DESIGN/DEVELOPMENT REVIEW COMMISSION
DESIGN REVIEW DISTRICT
HISTORIC AGENDA
EVALUATION SHEET
Case #4

ADDRESS: 2305 Lincoln Street

NATURE OF REQUEST: Request Certificate of Design Approval for exterior changes and preliminary certification for the Bailey Bill.

RIGHT ELEVATION 1/8" = 1'-0"

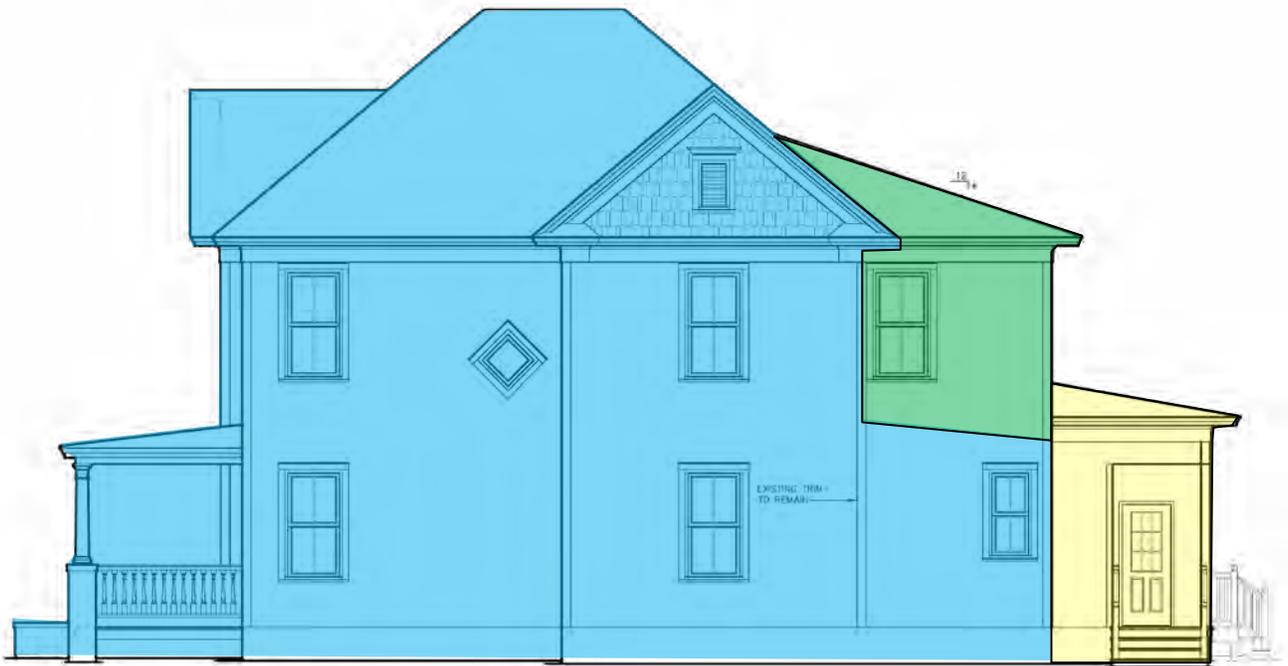
The rehabilitation proposal includes adding a second story to a previously enclosed 1-story porch on the rear of the house. It also includes removing an existing non-historic mudroom, open deck and screen porch on the rear to make room for a new 1-story laundry/mudroom with an open deck and rear stoop. The 2-story portion of the addition will utilize the existing footprint of the house while the new 1-story laundry/mudroom will be all new construction beyond the existing footprint. A small portion of the revised bathroom on the right rear corner will bump out as new construction as well.

Staff typically recommends stepping additions in 8"-12" to differentiate the new from the old, but doing so in this case would cause an unusual construction detail for the 2-story addition since it will be placed directly on top of the existing 1-story section of the house. The proposed new 1-story laundry/mudroom addition on the right rear; however, could be stepped in without resulting in any unusual detailing. As proposed, the 1-story addition provides access to the house via a recessed entry/stoop. This area features a narrow wall that is on the same plane as the existing house. Staff recommends recessing this wall slightly to preserve the original right side corner and to differentiate the all-new 1-story addition from the existing house.

Staff also noticed that the proposed recessed entry has an additional header feature shown on the elevations. Staff would recommend removing this element to make the entry/stoop more architecturally compatible with the front porch.

- *All historic architectural features including columns, windows, siding, and exterior decorative items shall be retained*
- *The right side wall of the 1-story laundry/mudroom shall be stepped in a minimum of 8" to differentiate the all-new addition from the existing house*

- *The additional header feature on the new side entry/ stoop shall be removed to be more architecturally compatible with the front porch*
- *The walls of the addition(s) shall be horizontal wood siding to match the thickness and reveal of the historic wood siding*
- *Any new windows on the additions shall be 2/2 wood windows with exterior muntins to match the existing historic windows*
- *All details deferred to staff.*

FOUNDATION PLAN 1/4" = 1'-0"

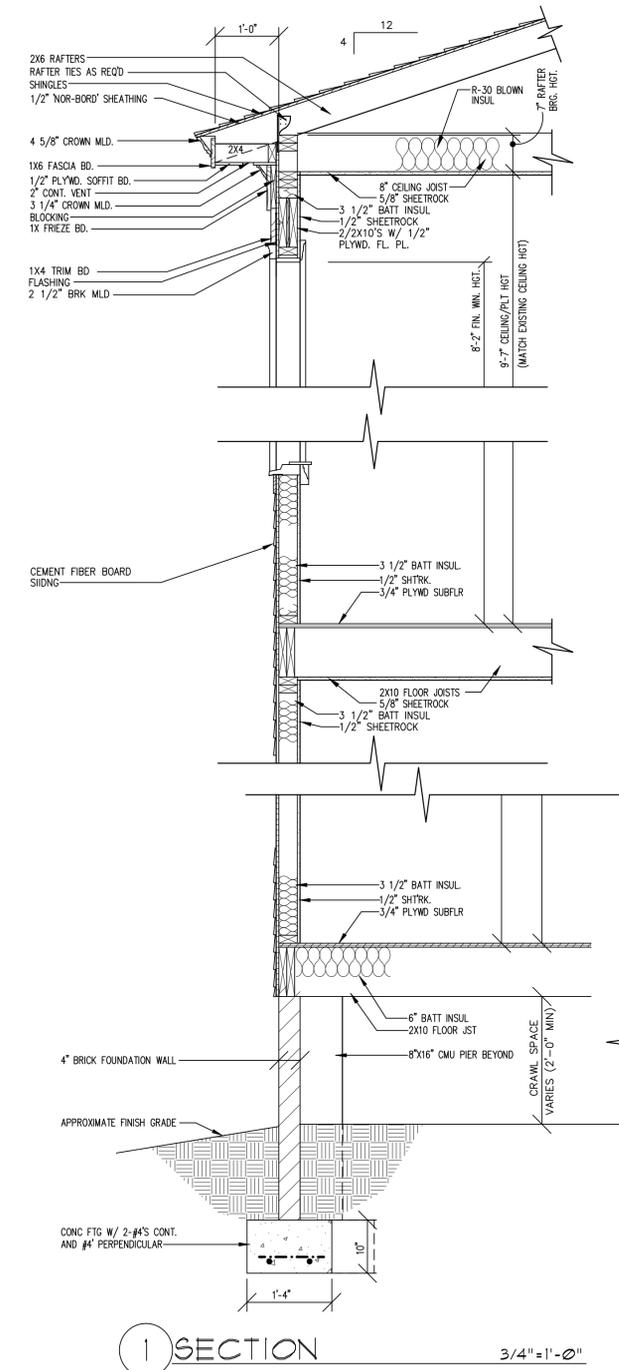
Foundation: The 1-story laundry/mudroom addition will require a new foundation. Staff recommends a brick foundation to match the existing historic brickwork.

ROOF PLAN 1/8" = 1'-0"

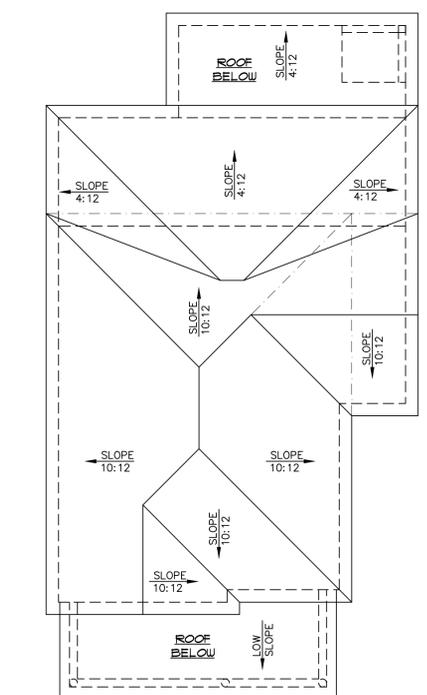
The proposed second story addition will utilize a half-hip roof with a 4/12 pitch that appears to continue the form of the existing 1-story section. Main roof pitches in the district are typically no less than 6/12, so the 4/12 pitch could be increased slightly to be more compatible with other houses in the district. Perhaps a 6/12 hip roof with a center ridgeline would work as well. Staff would be happy to work with the applicant on exploring these options. The new 1-story addition will feature a half-hip roof with a 4/12 pitch. All roofing surfaces will feature architectural shingles.
